# MODIFICATIONS TO

# CONTRACT EROSION PREVENTION

# SEDIMENT CONTROL (EPSC) PLAN

# CORINTH BRO 1447(29)

PHASE III - FINAL STABILIZATION
SITE SPECIFIC EROSION CONTROL PLAN

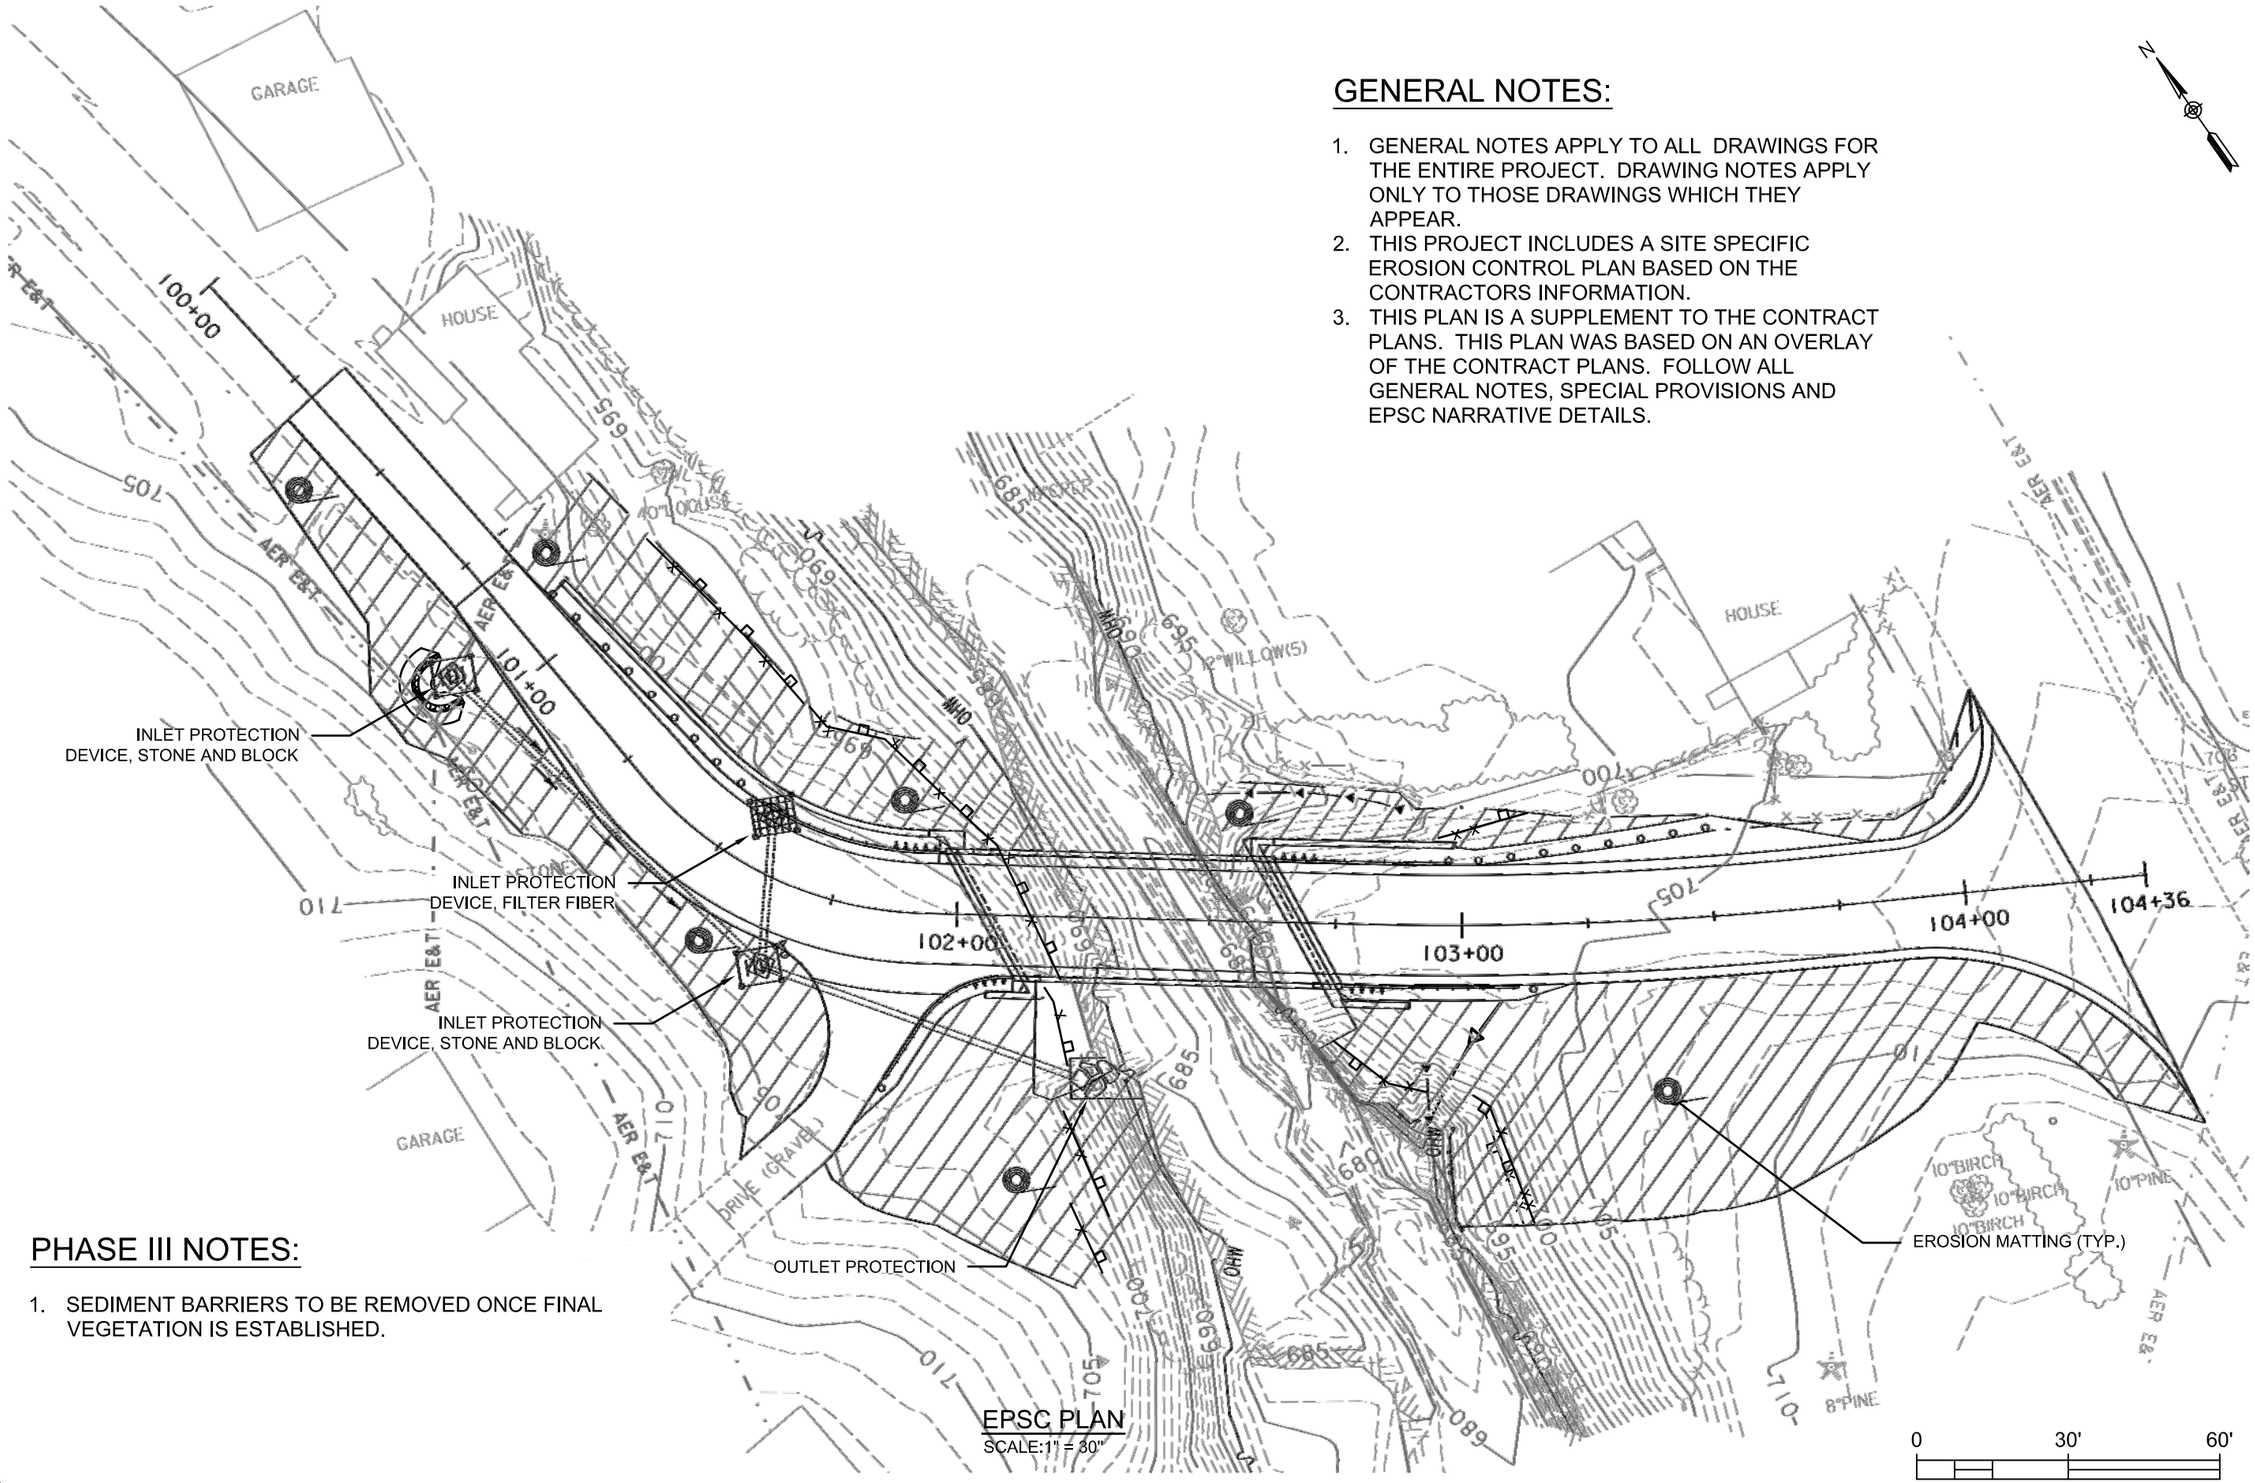
1.5.1.4. Detour Removal, Approach Construction and Intersection Construction.

The Detour will be removed and traffic will be moved to the final alignment. The detour disturbance will be restored and protected with final EPSC measures as shown on the plan.

1.5.1.5. Final Stabilization

Silt fence and culvert inlet protection will remain until vegetation has been established on the site. Once the site is stable, all structural measures will be removed and property disposed.

1. SEDIMENT BARRIERS TO BE REMOVED ONCE FINAL VEGETATION IS ESTABLISHED.
